# CITY OF ALBUQUERQUE

**RE: Lobo Logistics**  
**7850 La Morada Place NW**  
**Grading and Drainage Plan**  
**Engineer's Stamp Date: 10/31/24**  
**Hydrology File: H10D038**

ENGINEER'S SEAL	TRACT 11-C LADERA BUSINESS PARK UNIT 1 LA MORADA PLACE NW	DRAWN BY DEM
DAVID SOULE 14522 REGISTERED PROFESSIONAL ENGINEER	GRADING AND DRAINAGE PLAN	DATE 10-31-24
10/31/24	Rio Grande Engineering	La Madera Place.dwg
DAVID SOULE P.E. #14522		SHEET # C1
		JOB #

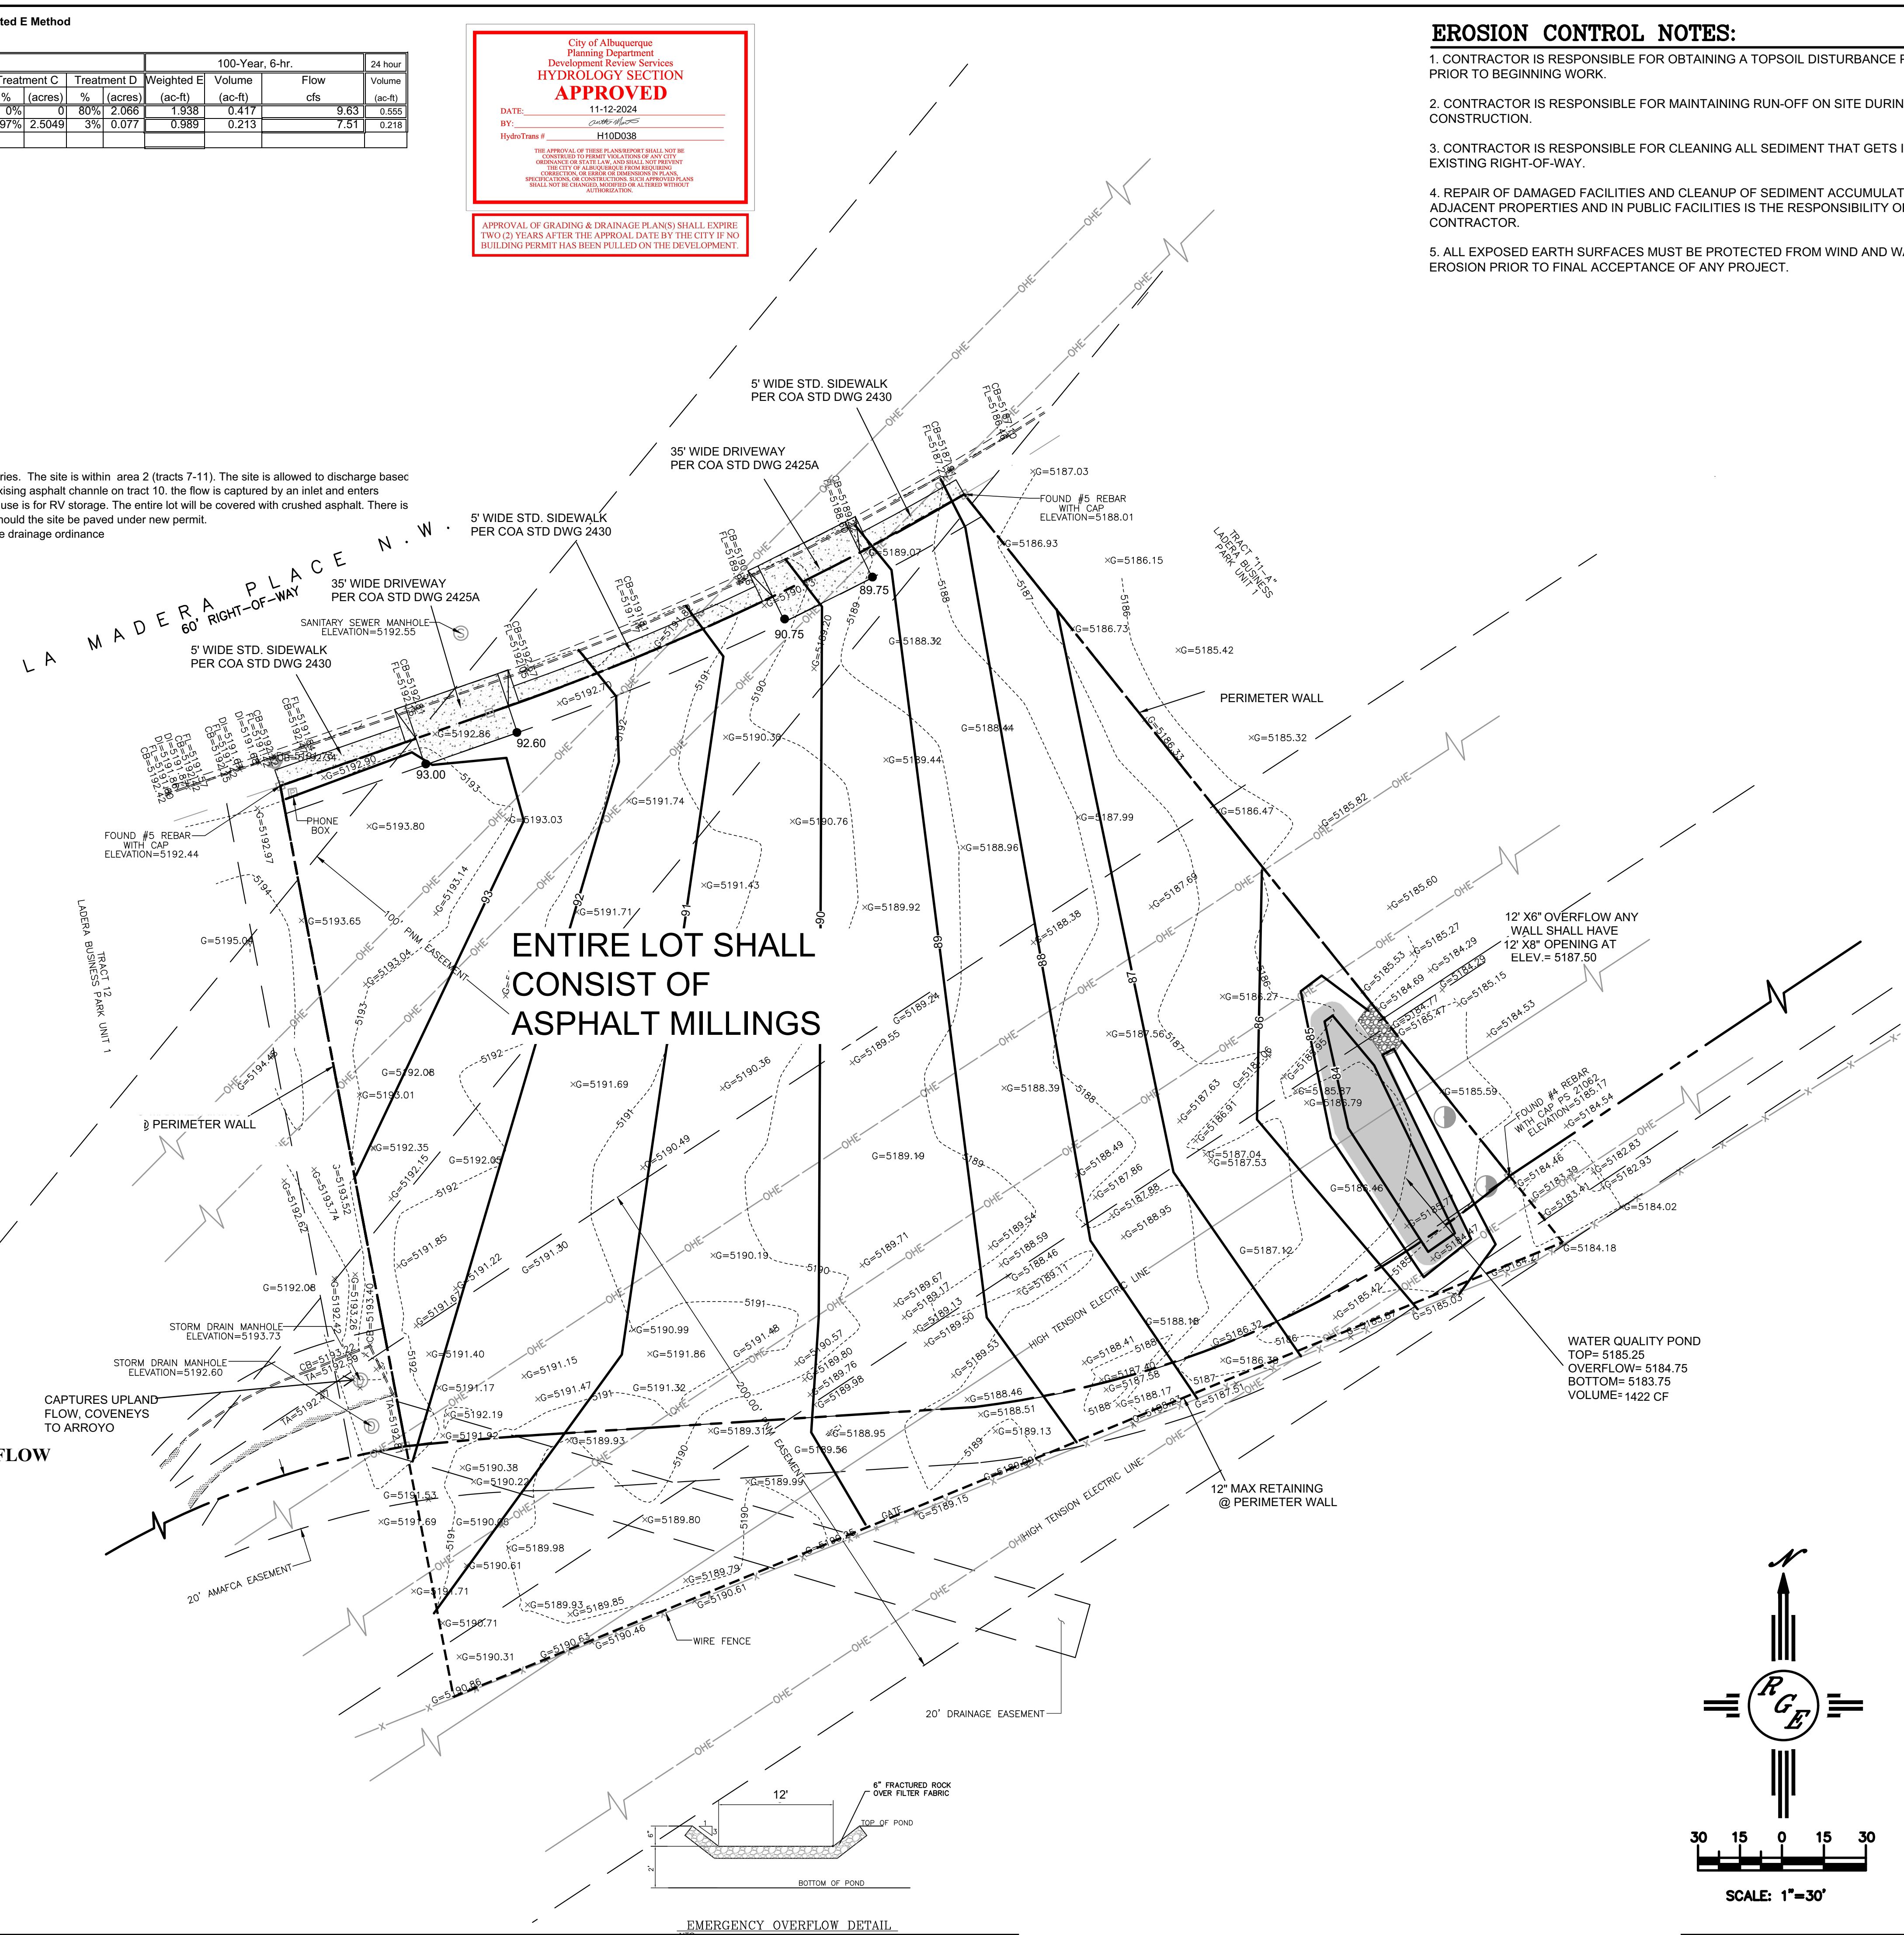
Based upon the information provided in your submittal received 10/31/2024, the Grading and Drainage Plan is approved for Building Permit and Grading Permit. Please attach a copy of this approved plan in the construction sets for Building Permit processing along with a copy of this letter.

1. Engineer's Certification, per the DPM Part 6-14 (F): *Engineer's Certification Checklist For Non-Subdivision* is required.
2. Please provide the executed paper Drainage Covenant (latest revision) printed on one-side only with Exhibit A and a check for **\$25.00** made out to "**Bernalillo County**" for the stormwater quality ponds per Article 6-15(C) of the DPM to Hydrology for review at Plaza de Sol.
